Lead Block Slot Condition

B1 and B2

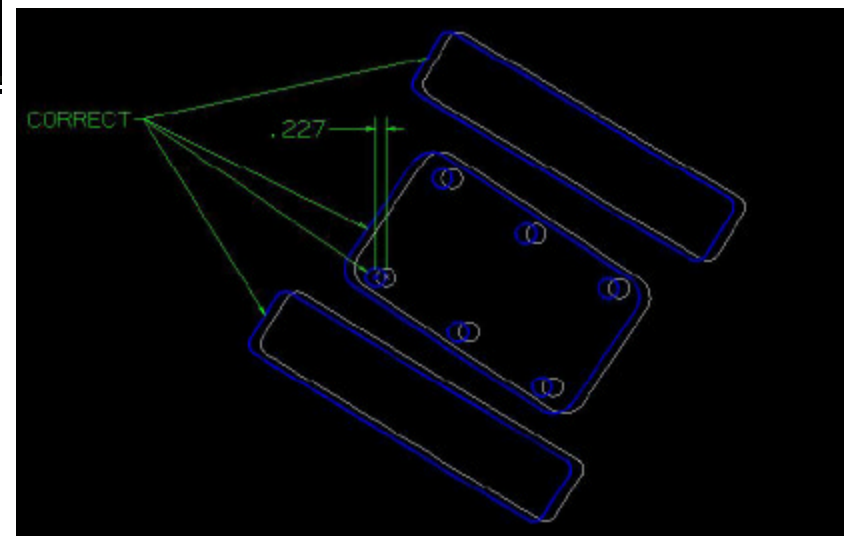
The slots are off approximately .150" to .200" along the long side and .175 to .225" along the short side.

The face of the pad on B2 has been machined to the correct thickness which required approx. .5" of material removal.

B1 still has the additional .5" of stock.

B1 and B2

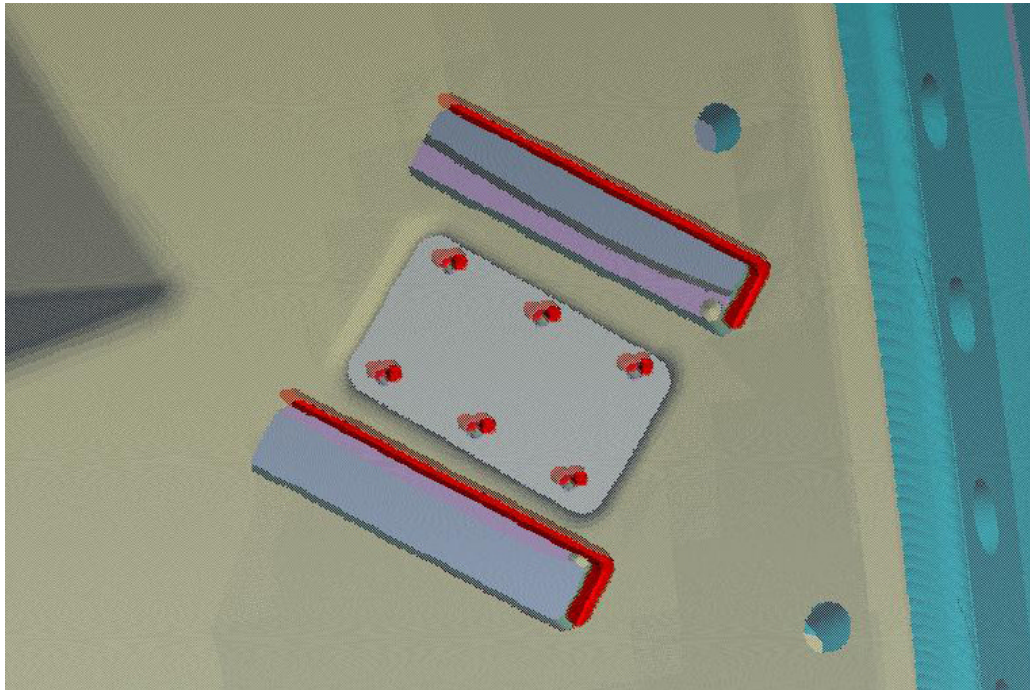
The red color around the slots would represent areas that are presently machined that would be outside of the slot tolerance if the slots are moved to their correct location.

Proposed Remedial Action:

B1

- Assuming that the out of tolerance conditions would functionally be acceptable, MTM proposes that B1 remain unchanged.

B2

- Correct the location of the lead block slots and holes. This would move the holes onto the surface of the pad which would eliminate the need for the earlier proposed filler block. The slots would then have the condition described on page 2.
